STAFF REPORT 02-07-2024 MEETING

APPLICATION NUMBER: HDC2024-00020

ADDRESS: 477 WEST ALEXANDRINE

SCOPE: ERECT MULTI-FAMILY BUILDING WITH REAR PARKING LOT

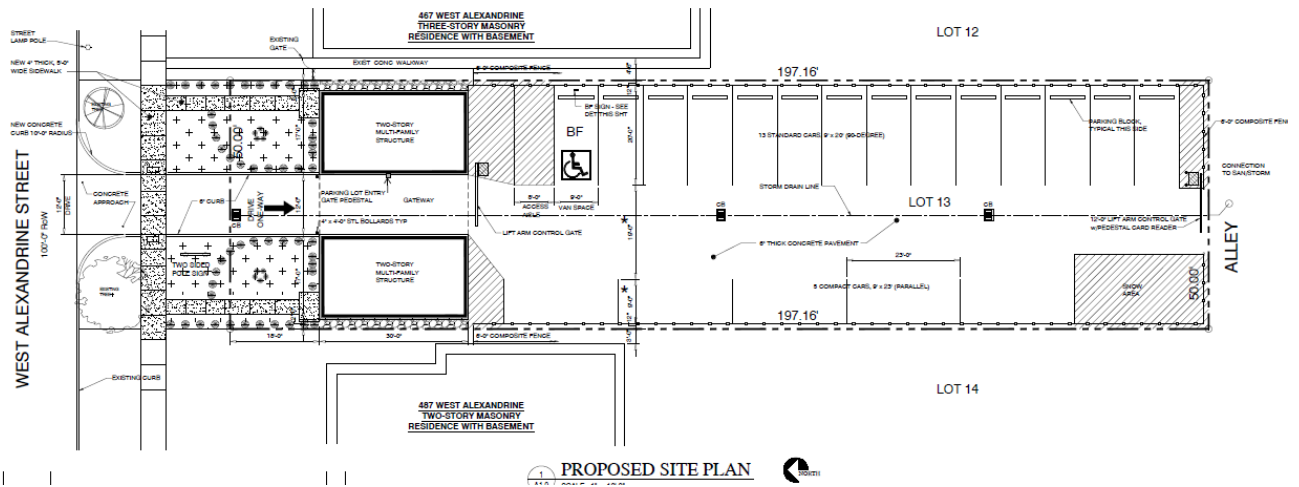
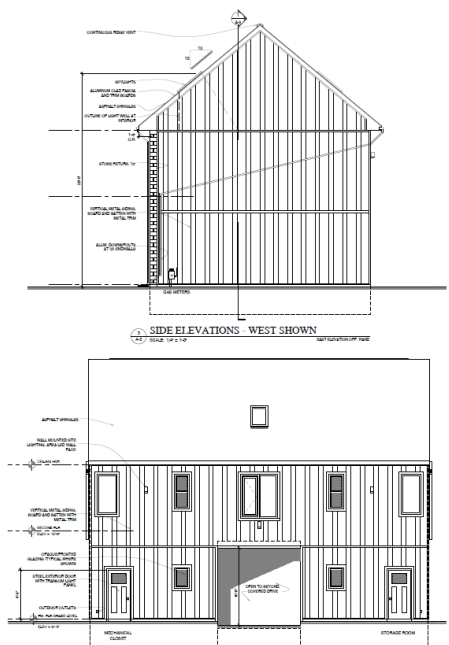
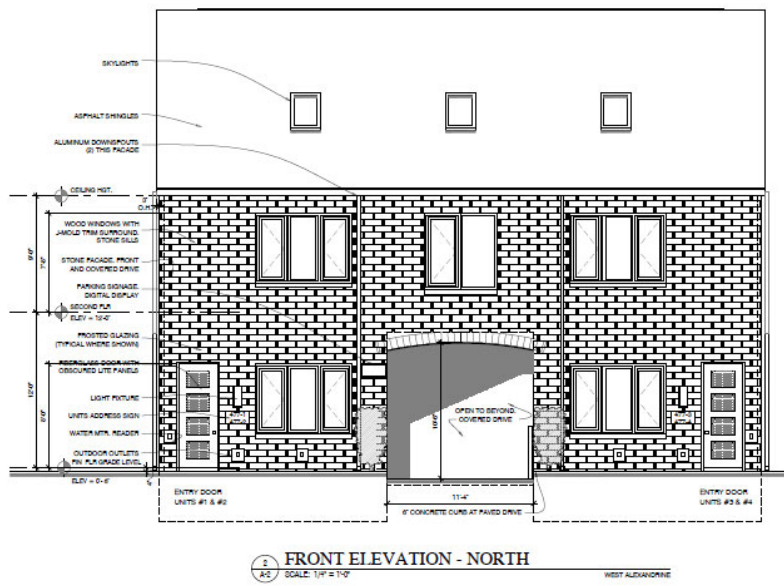
Application submissions, including site plan (above), front elevation (below left), and side/rear elevations (below right). Note side/rear elevations are proposed to be metal panel. Images not to scale. Compare architectural front elevation here, featuring coursed stone, to the rendered elevation on the next page.

- However, what is less compatible, in staff’s opinion, are some of the details proposed for the building. For instance, Element 6, which describes entrances and porch projections, notes that entrances are often set beneath gable-roofed or arched openings. The proposal features a basically flat front elevation with no projections – a projecting gable or arch canopy over the entry drive, sensitively handled, would address this deficiency and move the building towards conformance. Similar projections should appear over the flanking residential entry doors to add interest and depth to the façade.

- Elements 7 and 8 (materials/textures) focus on the preponderance of brick in the district, offset with stone trim. While there are two notable examples of fully stone buildings (that being the Campbell-Symington House at 650 West Alexandrine, and the apartment building across the street, both located west across 2nd Avenue from this block), both of these buildings are distinctive historic landmarks of exceptional individual character and importance. The Campbell-Symington House is even designated as its own individual historic district. A *typical building* in Willis-Selden, (such as a new infill building) in staff’s opinion, should be expected to mix into the “general population” of the district. As such, it should be of a dark-colored brick, with stone accents. Modern squarish rubble-style stone veneer (non-coursed stone) as depicted in the submitted rendering, is particularly difficult to convincingly incorporate into a historic context, as it is typically used for inexpensive buildings of standard builder quality. Similarly, metal panel is not compatible in this context, except perhaps at the rear elevation only.

- Element 11 highlights the important complexity found in roof shapes and related details, including chimneys. The proposal offers a very plain side-gabled roof, with only gutters and skylights offering minimal visual interest. The metal panel sides have no windows at all. In staff’s opinion, the proposal should add additional complexity and detailing to the roof to conform to this Element.

- Element 18 suggests that a multi-family building should occupy between 20-40% of their lot. Similarly, Element 15 suggests that a building of “moderate to large” scale is appropriate. The proposal appears to be deficient as the footprint of the building (46’ wide by 30’ deep) yields 1,380 square feet, or approximately 15% of the 10,350 square foot parcel. To increase both scale and lot coverage, the building could incorporate a raised first floor level (which could additionally add architecturally complex stoops and porches, addressing Element 6, 11, and 19) while extending several feet deeper into the lot (15’ deeper would be required to reach 20% coverage).

- The building will be increased in scale, by elevating the first floor and extending its footprint to the rear to increase lot coverage.
- The façade will be revised from modern veneer stone to true brick featuring stone trim, with areas of stucco or wood at the sides and rear, if desired. The brick should be reddish or dark.

- The roofline will be redesigned with greater complexity (architectural detailing, chimneys, dormers, etc.) befitting the building’s proposed traditional form. Windows may be added at side elevations to achieve a more complex appearance.

- Canopies or porch projections will be added to the front façade, over both front doors and over the vehicle passageway.
- Windows will be standard vision glass and not be highly reflective or feature internal “grids”

- The site fence will be wood, metal, masonry, or other traditional material instead of PVC, in a design appropriate for the context.
- The parking lot will remain visually subordinate to the building, concealed from view, and shall not exist separately from the building. Permit application for a larger parking lot in excess of the minimum number of spaces required by code for the 4-unit building, and the corresponding application for “public parking” signage, will be duly approved by historic staff only after substantial completion of the building.

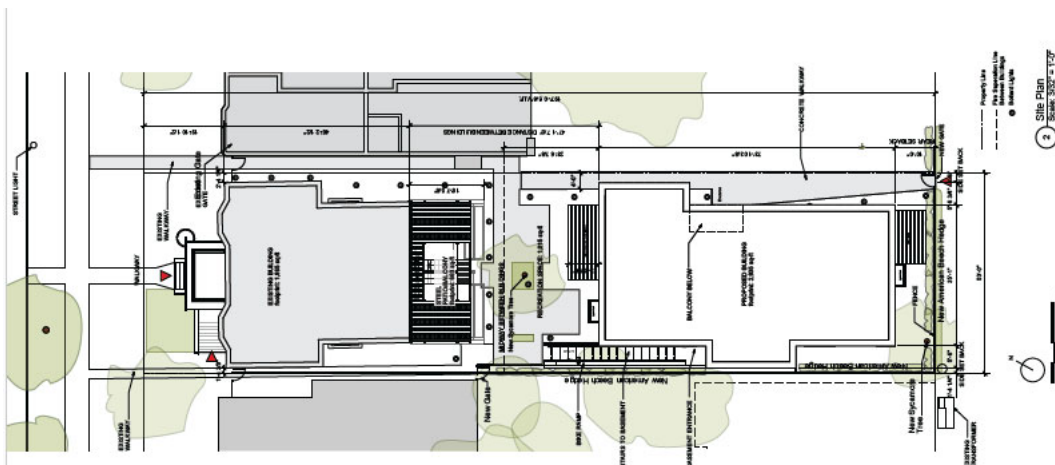
Rendering of proposed project provided by the applicant. Note that the stonework depicted here is of a substantially different character (i.e., contemporary) than the more traditional coursed stone depicted in the front elevation (previous page). The windows are depicted with a high degree of reflectivity, almost as mirrors, which would be inappropriate, in staff's opinion.
